To: Town of Amenia Planning Board

Memorandum

Re: Comments related to Silo Ridge's February 19, 2015 Submission - Responses

The Applicant offers the following responses to the comment memorandum from George M. Janes & Associates dated April 20, 2015 regarding the Silo Ridge February 17, 2015 Submission Review.

Figure 1: Detail from C4.14 showing the WWTP.

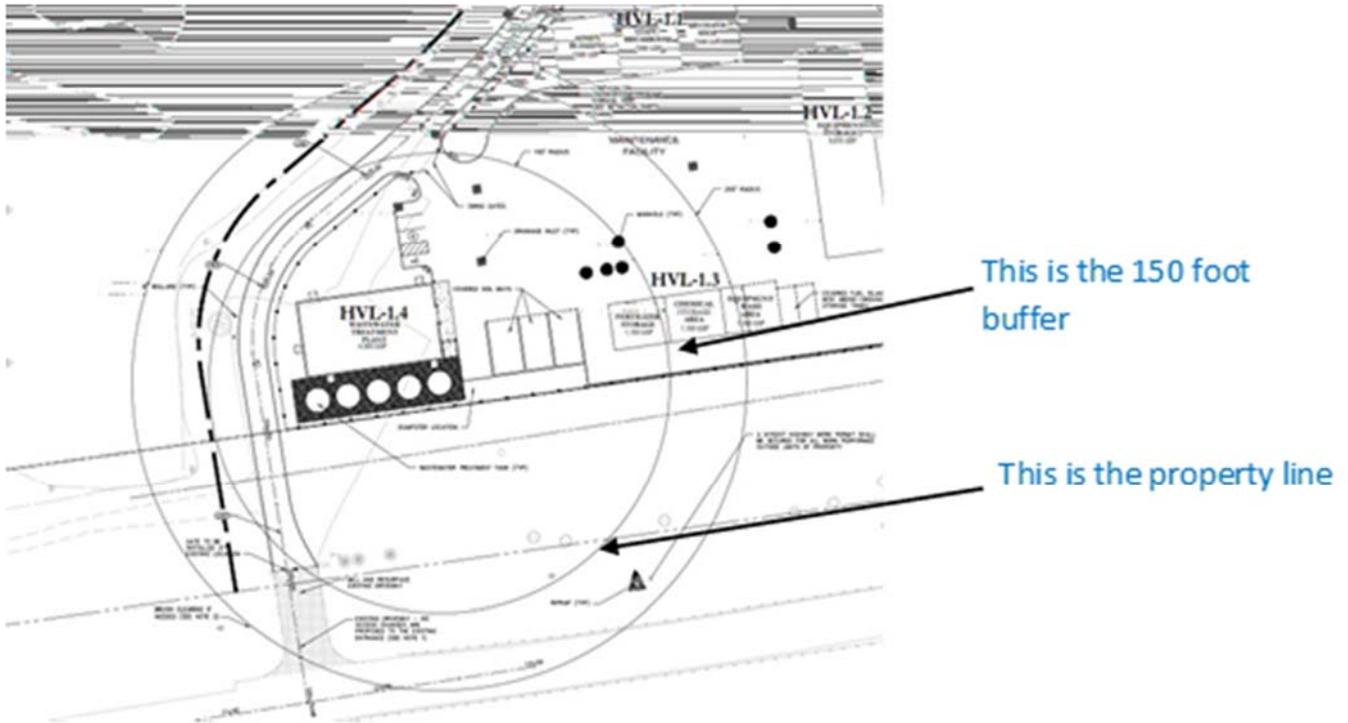
It is noted that the applicant's response to this comment states that treatment unit of the WWTP must be 150 feet from adjacent property lines. While I defer any further comment to the Town's engineer, drawing C4.14 shows that the facility is within 150 feet of Route 44 property line, the portion of which is reproduced below:

Comment noted.

Figure 2: 2014 plan showing which buildings are visible in the visual simulations.

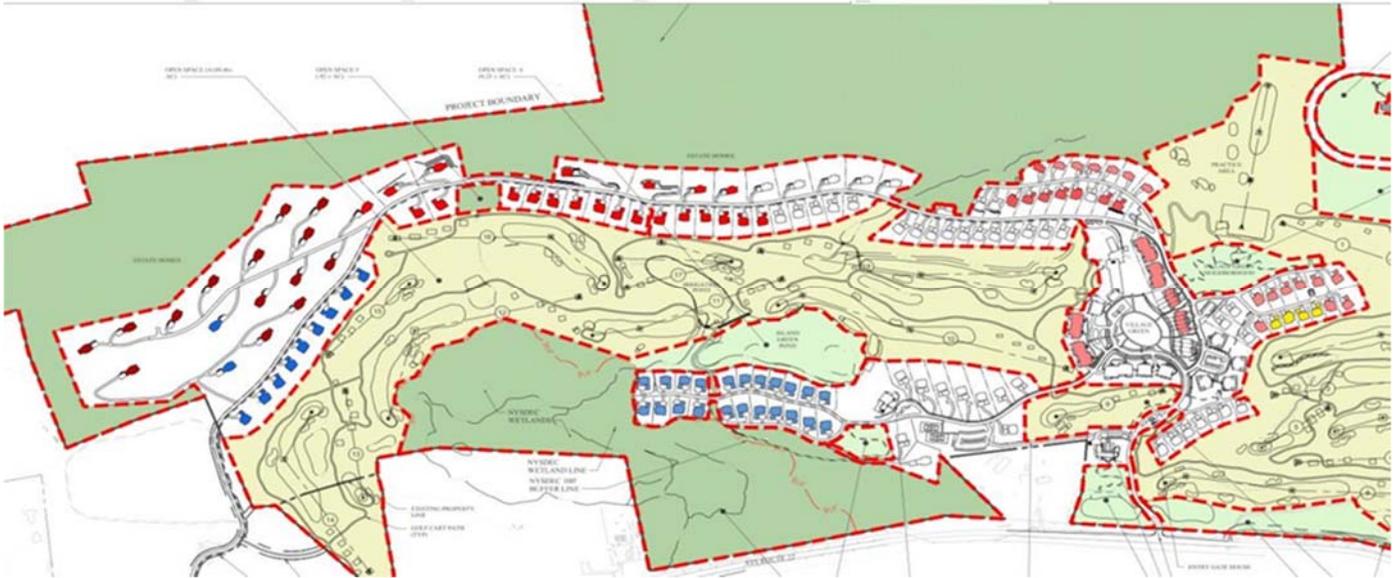
The MDP states that 78% of the buildings proposed will not be visible from public places. There are several problems with this statistic. First, the applicant provides no evidence as to how this number was calculated. Second, it is contrary their own evidence. Third, it is not clear that this statistic has any meaning in the context of SPO standards.

The visual simulations show that about 35% of the buildings are not visible from the viewpoints analyzed, which is quite a difference from the 78% claimed in the MDP. There have been significant changes in the plan in the Estate Home area, but these changes are unlikely to make any of these buildings not visible from public areas due to their elevation high above the valley floor.

For its decision-making the Planning Board should ignore the 78% statistic found in the MDP, and rely upon the visual simulations for understanding the project's impact on the Town's visual resources. That said, whether it be 35%, 78% or some other number, I do not believe that this statistic is material to showing compliance with the Town's SPO.

Comment noted. The Applicant has removed the statistic from the MDP text.

Figure 4: Detail from L3.14, showing unnecessary planting.

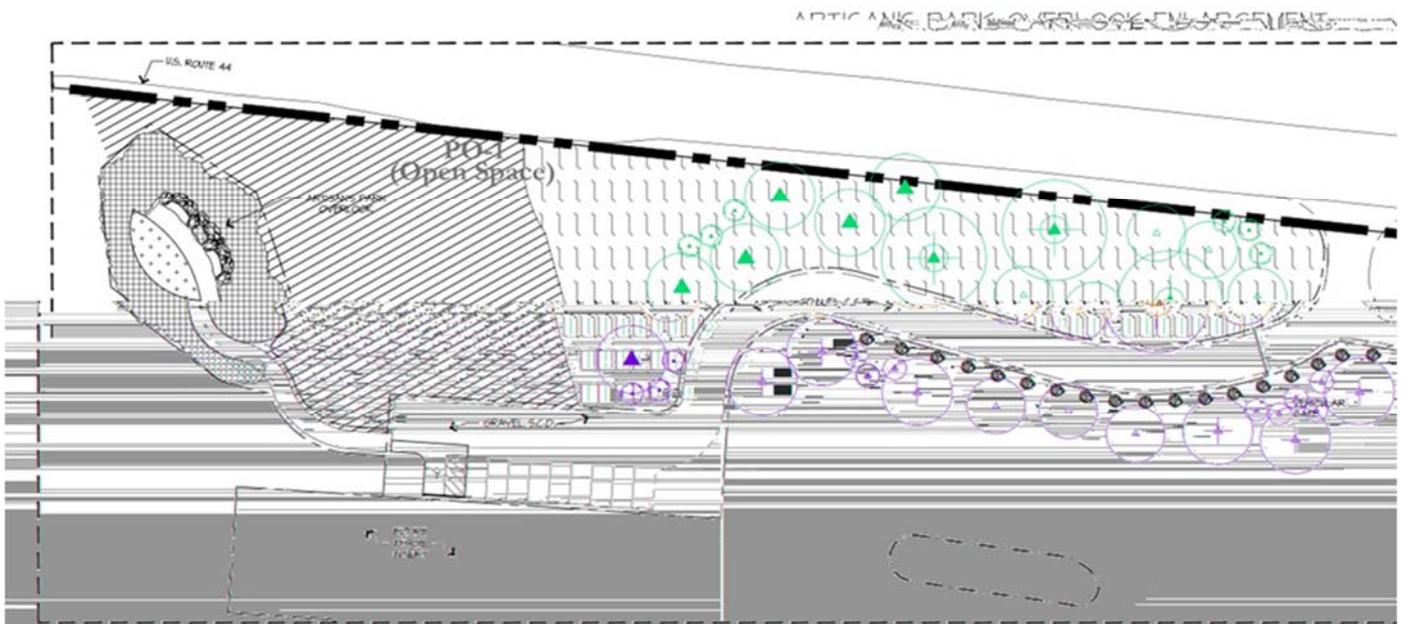
- a. There are a number of landscaping changes proposed, most of which are beneficial to visual resources. The landscaping shown in L3.02 and L3.14, in the area at the entrance to the Overlook, needs to be changed, however. The plans for this area show a thick vegetative buffer along Route 44 as seen in green below:

The FEIS showed a similar thick vegetative buffer here expressly to screen the planned winery-themed restaurant located behind this screen from Route 44. Because the restaurant is planned in the next phase of the project, this vegetation would serve no beneficial screening purpose during this phase, and may negatively impact the openness of the view at the top of the hill. Further, landscape screens are best evaluated during site plan review when there is a plan for the element it is designed to screen, and since the restaurant is in the next phase of the project, there is no plan. It is simply premature to install this landscaping during this phase, and the Planning Board should have the

applicant remove the landscaping planned at the entrance to the Overlook. This could be a requirement of the Findings Statement.

Comment noted. As per the Planning Board's direction, the Applicant provided a revised plan removing any landscaping at the entrance to the Overlook and future Winery Restaurant. Additionally, the Applicant agrees that evaluation of the screening for this area during site plan review would be an appropriate condition of the Findings Statement.
